Technical Service Bulletin: tsb100630

Released Date: 27-Sep-2007

Modified Piston Cooling Nozzles

Modified Area of Piston Cooling Nozzle

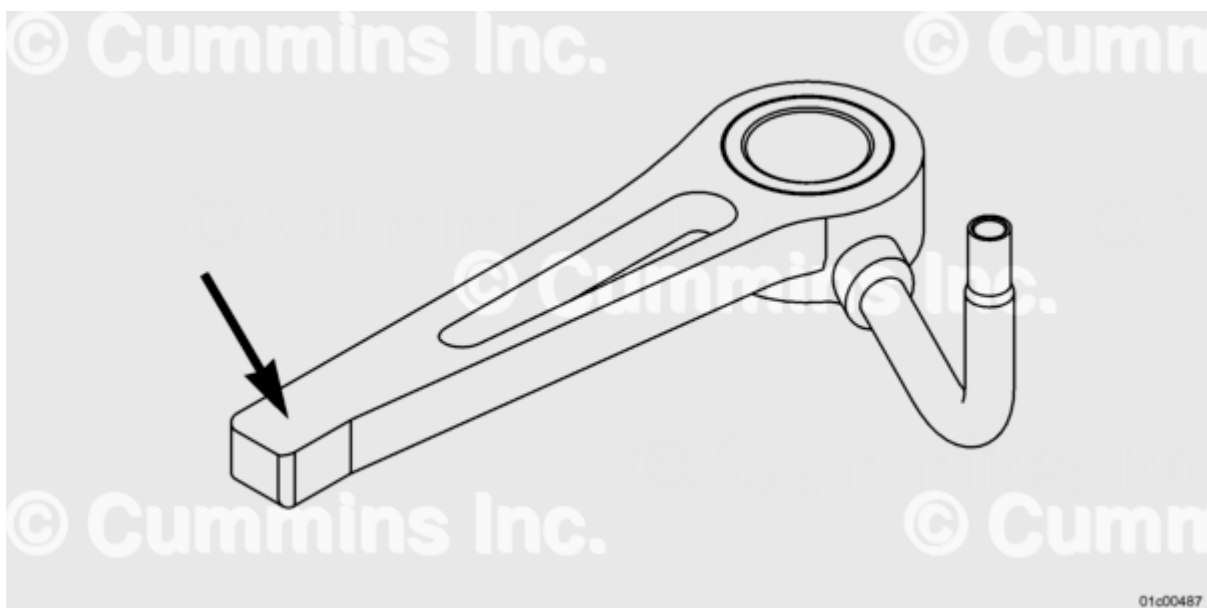
The reason for the use of modified cooling nozzles is due to a casting shift in the engine block. The cast piston cooling nozzle alignment notch section of the block did **not** allow the nozzle to seat against the mounting screw spot face without interference. When the nozzle mounting screw is torqued to specification the plastic alignment arm of the nozzle is put in distress. A fracture to the plastic section of the nozzle could result in loose pieces inside the engine, and could cause loss of nozzle alignment.

The piston cooling nozzle has been modified. The plastic alignment arm has been sanded down to fit the cast alignment notch in the block. These nozzles have been modified 'by hand'; therefore, the modifications to the nozzles do vary.

**If a nozzle is replaced from these engines, the new nozzle must be modified to fit the block.
Failure to modify nozzles for these blocks could result in engine damage.**
